Access Compliance Report

Public Rights-of-Way

(Curb Ramps)

Intersection ID: 7616	Main Street: GEORGETOWN_DR	Cross Street: SPRING_GARDEN_LN	Location: NW
ADA ID: EB588D1A4190	Ramp Type: BlendTrans1	Initial Pass/Fail: Fail	Overall Compliance: No
		Severity Score: 8.75

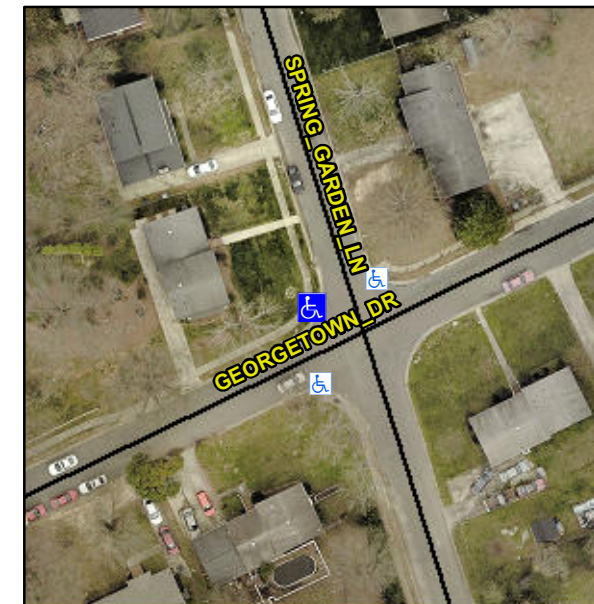
PROW/ADA:

Not Found, R304.5.1

Compliance	Description	Data	Compliance	Description	Data
N/A	Ramp Length (in)	47.0	Yes	BlendTrans Slope (%)	4.4
No	Ramp Width (in)	38.0	Yes	BlendTrans XSlope (%)	0.5
N/A	Flare Type LT	N/A	N/A	Flare Type RT	N/A
N/A	Flare Slope LT (%)	N/A	N/A	Flare Slope RT (%)	N/A
N/A	Flare Traversable LT?	N/A	N/A	Flare Traversable RT?	N/A
N/A	Landing Length (in)	N/A	N/A	DWS Provided?	N/A
N/A	Landing Width (in)	N/A	N/A	DWS Contrast?	N/A
N/A	Landing Slope (%)	N/A	N/A	DWS Length (in)	N/A
N/A	Landing X Slope (%)	N/A	N/A	DWS Full Width?	N/A
N/A	Landing Curb? (Y/N)	N/A	N/A	DWS Offset (in)	N/A
N/A	Shared Landing?	N/A			
N/A	Gutter Ponding?	N/A	N/A	Gutter Slope (%)	N/A
N/A	Gutter Lip Ht (in)	N/A	N/A	Gutter X Slope (%)	N/A
N/A	Painted X Walk1?	No	N/A	Painted X Walk2?	No
	X Walk 1 Direction	To S		X Walk 2 Direction	To E
	X Walk 1 Width (in)	N/A		X Walk 2 Width (in)	N/A
	X Walk 1 Slope (%)	2.5		X Walk 2 Slope (%)	5.1
	X Walk 1 X Slope (%)	3.0		X Walk 2 X Slope (%)	3.0

N/A	Ramp inside XWalk1?	N/A	N/A	Ramp inside XWalk2?	N/A
	Road Slope (%)	0.1		Clear Space?	N/A
	Road X Slope (%)	5.0	N/A	Clear Space to XWalk (in)	N/A
N/A	Any Obstructions?	N/A	N/A	Storm Grate/Utility Hazard?	N/A
	Obstruction Type			Storm Grate/Utility Type	
		N/A			N/A
			Yes	Surface Condition? (G/P)	Good
			No	Curb Slope (%)	32.6

Possible Solutions:

Remove & Replace Curb Ramp With Two New Directional Ramps or Equivalent.
